**CERTIFICATE OF APPROPRIATENESS**

**Property:** 4019 Inverness Drive, Track 10 and 11A, Block 90, Tall Timbers section of River Oaks. The property includes a historic 5,900 square foot single-family residence and attached 1,040 square foot garage situated on a 43,200 square foot corner lot.

**Significance:** The Tone-Howe House is a protected landmark residence built in the Southern Colonial style. This country house type of residence was designed by Architect Birdsall Briscoe and constructed circa 1957.

**ROOF PLAN – ATTACHED GARAGE**  
**EXISTING**

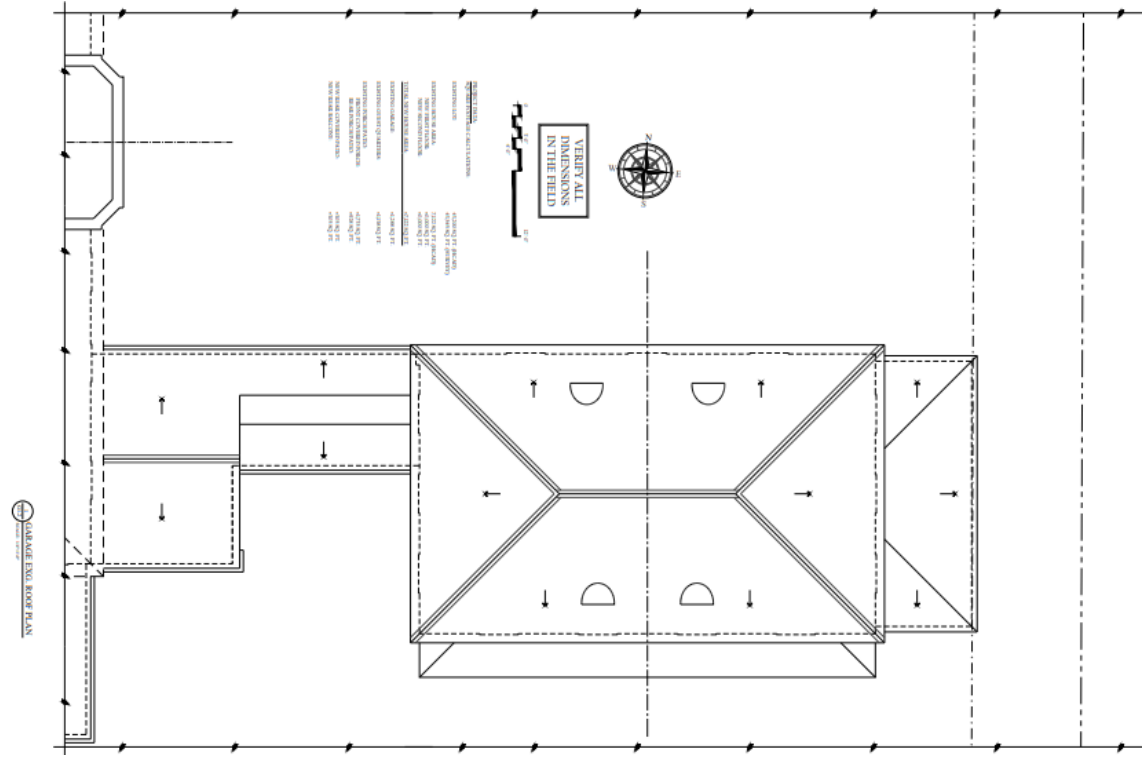
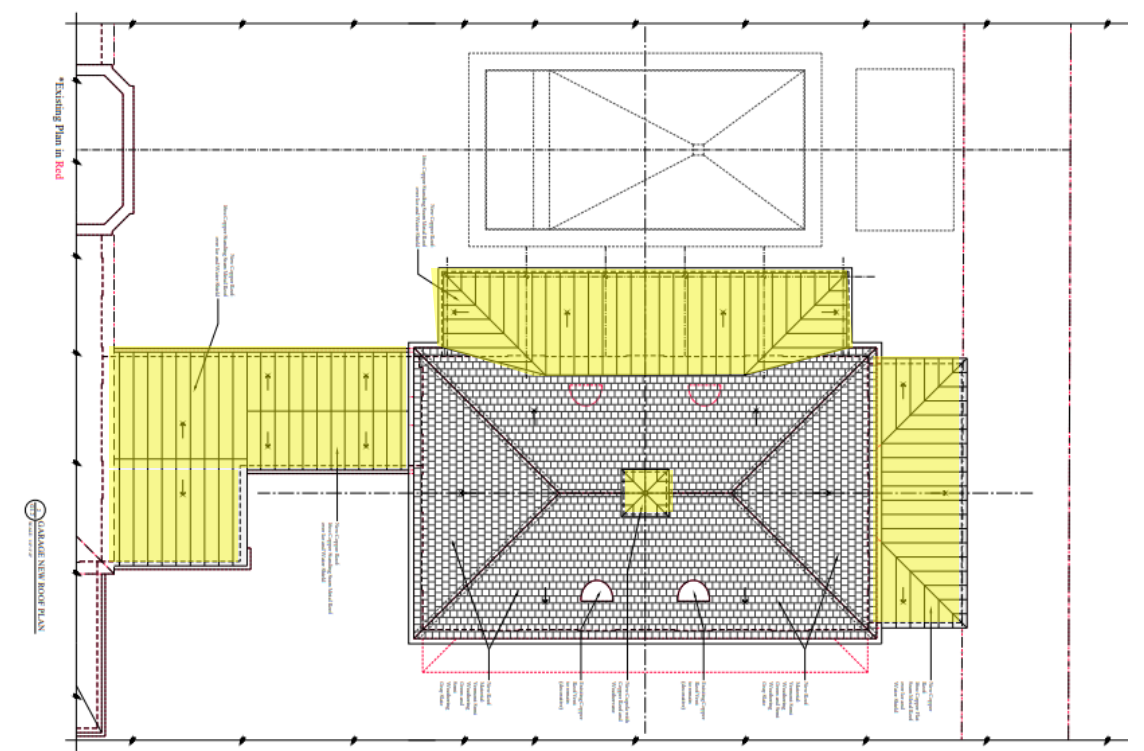
- **Cupola:** The proposed addition of a cupola to the roof ridge of the garage is designed to serve as a light well to provide daylight for the living and kitchen space in the renovated guest suite. The cupola will be wood construction with glass panes, a copper cap and a copper weathervane.

**Staff Recommendation:** Deny installation of cupola, restore or replace metal awning in similar style/design/material, retain original garage door openings on attached garage. Repair or replace garage doors, maintaining original opening. If replacement of garage doors and/or awning are deemed necessary (by staff), final designs to be approved by staff.

**SOUTH ELEVATION – FRONT FACING DEL MONTE DRIVE (GARAGE)**

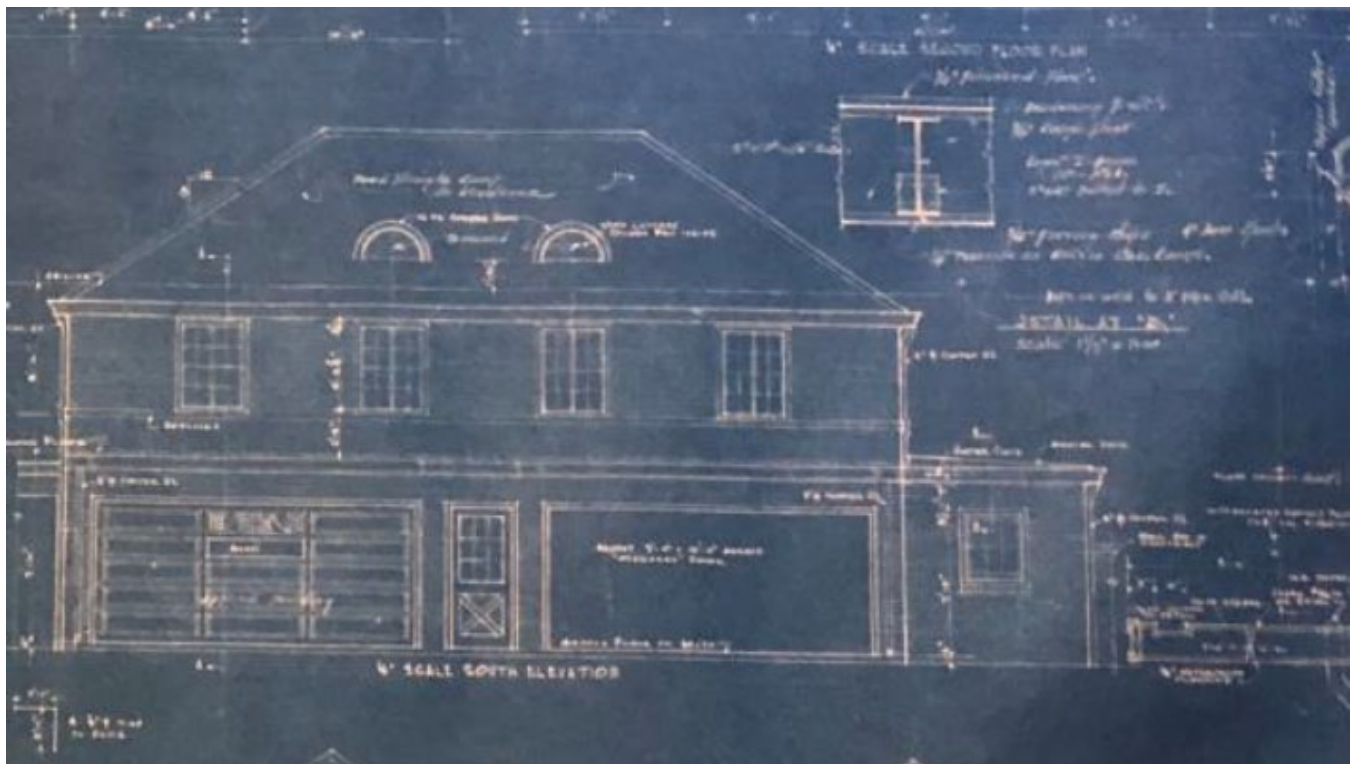
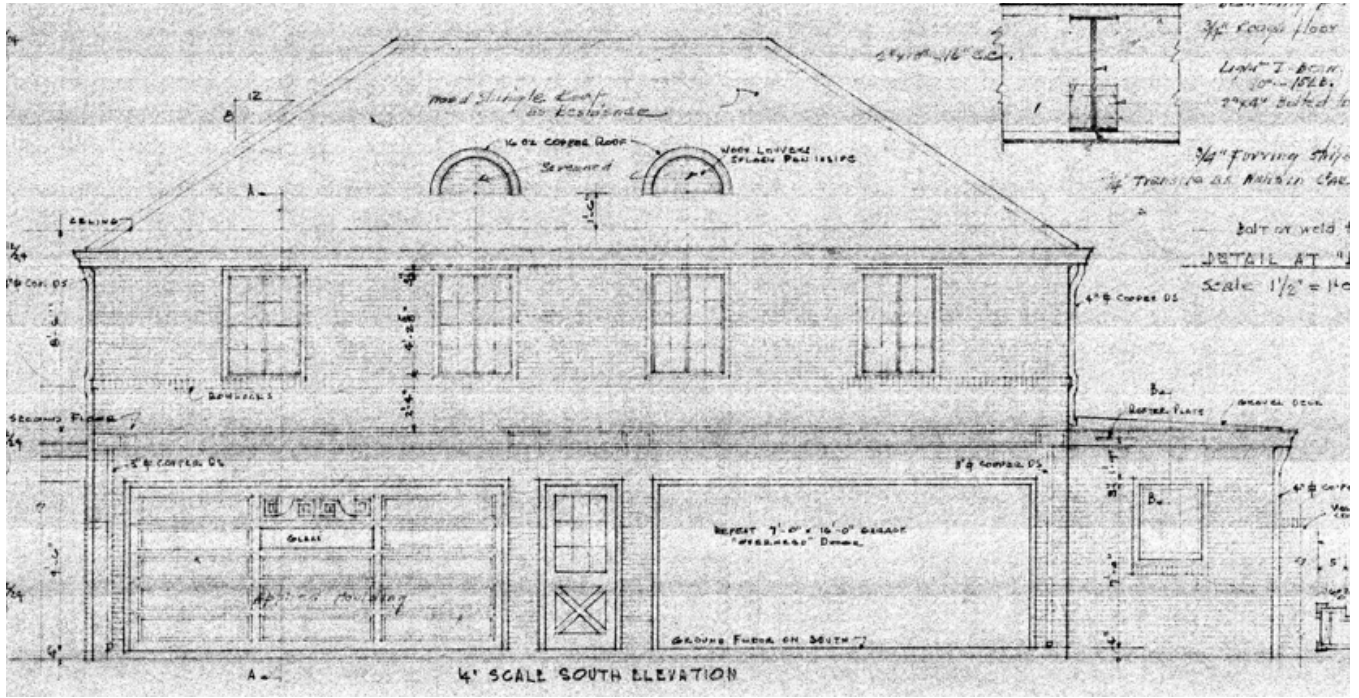
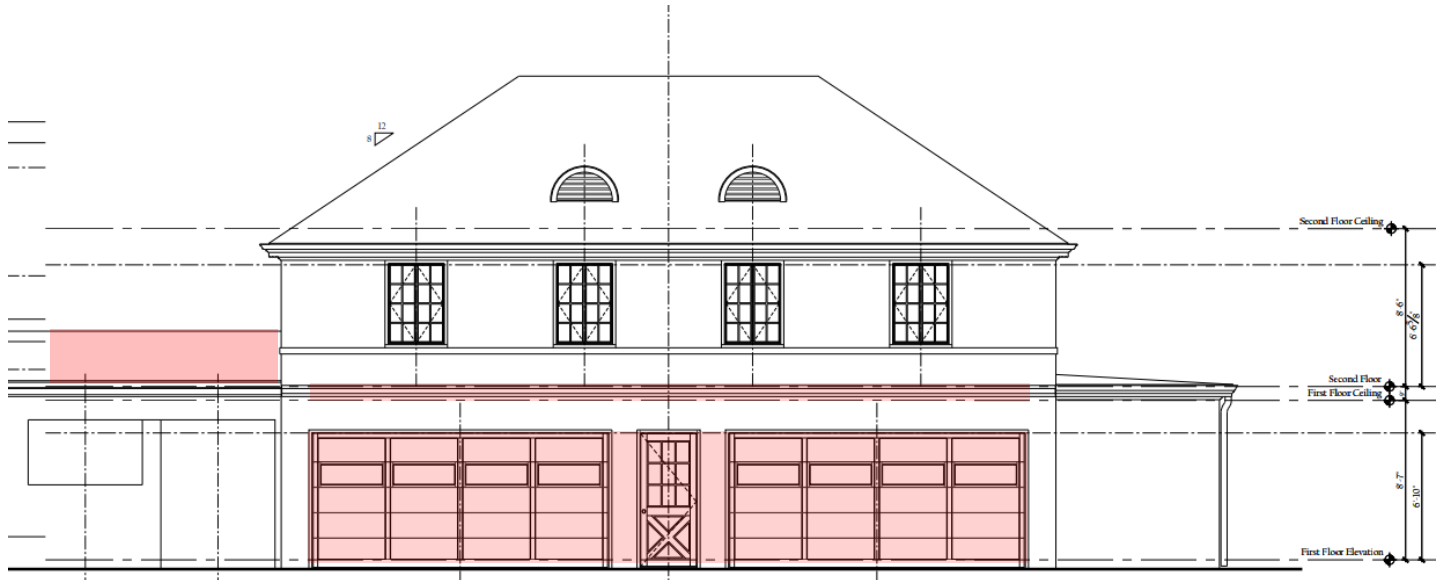
| <input type="checkbox"/>            | <input checked="" type="checkbox"/> | <input type="checkbox"/>            | (3) The proposed activity must recognize the building, structure, object or site as a product of its own time and avoid alterations that seek to create an earlier or later appearance;<br><i>Design of 3 garage doors attempts to replicate existing 2 historic doors in a smaller format thus attempting to create an earlier appearance.</i>  |
| <input type="checkbox"/>            | <input checked="" type="checkbox"/> | <input type="checkbox"/>            | (4) The proposed activity must preserve the distinguishing qualities or character of the building, structure, object or site and its environment;<br><i>Alteration of garage door openings and removal of historic doors (garage doors and entry door), added cupola, and application of trellis (as proposed replacement of simple, mid-century metal awning) actively alter the simple appearance of the garage design. Proposed changes collectively create a busy appearance that alters the character of the building.</i>  |
| <input type="checkbox"/>            | <input checked="" type="checkbox"/> | <input type="checkbox"/>            | (8) Proposed additions or alterations must be done in a manner that, if removed in the future, would leave unimpaired the essential form and integrity of the building, structure, object or site;<br><i>Proposed changes to the garage entrance and garage door openings would alter the essential form and structure.</i>  |
